SUBJECT: Forwards changes to FSAR Chapters 6 & 11, deleting NSSS interface unit between process radiation & gas stripper effluent monitors & RMS computer sys & deleting line coming off discharge header of antifoam pump.

Subject: Palo Verde Nuclear Generating Station (PVNGS)
Unit 3
Docket No. STN 530
Changes to the FSAR Concerning Chapters 6 and 11
File: 86-E-005-419.05; 86-G-056-026

Attached for your review on PVNGS Unit 3 are FSAR changes to Chapters 6 and 11. These changes involve (1) deleting the NSSS interface unit between the process radiation and gas stripper effluent monitors and the RMS computer system; (2) deleting the line coming off the discharge header of the Antifoam Pump to the Boric Acid Concentrator; and (3) clarifying the FSAR to accurately reference the proper Technical Specification Sections.

FIGURE 11.5-1

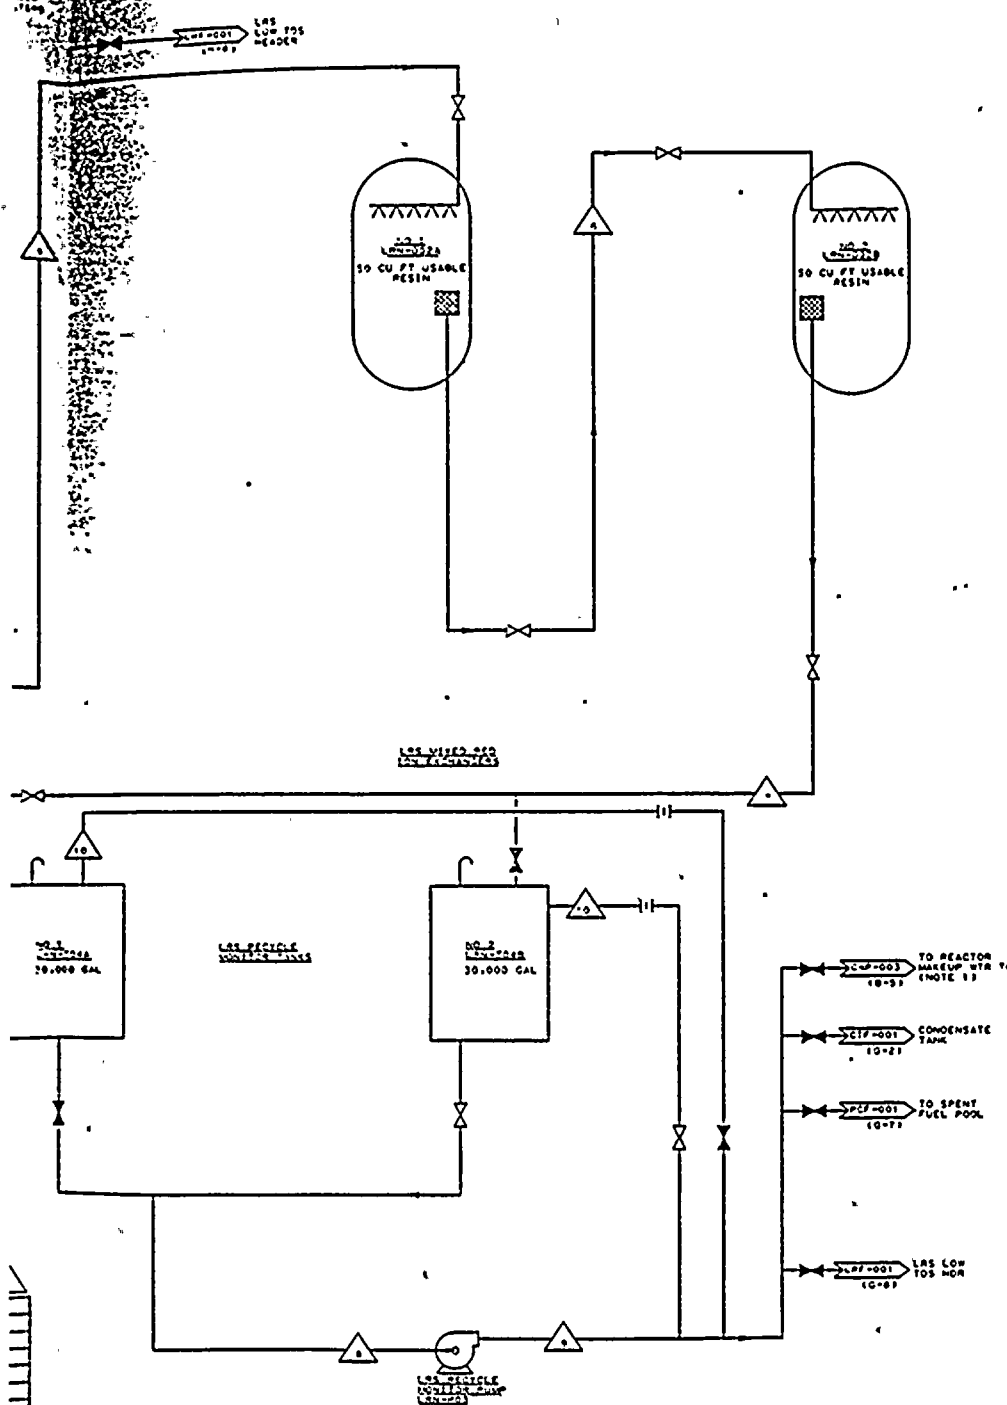
These changes are justified because: (1) this change will increase the efficiency of the RMS computer system and control room indication is still available; (2) ridding the reactor coolant system of the anti-foam agent was not necessary nor practical; (3) in a previous amendment to the FSAR, the references were incomplete.
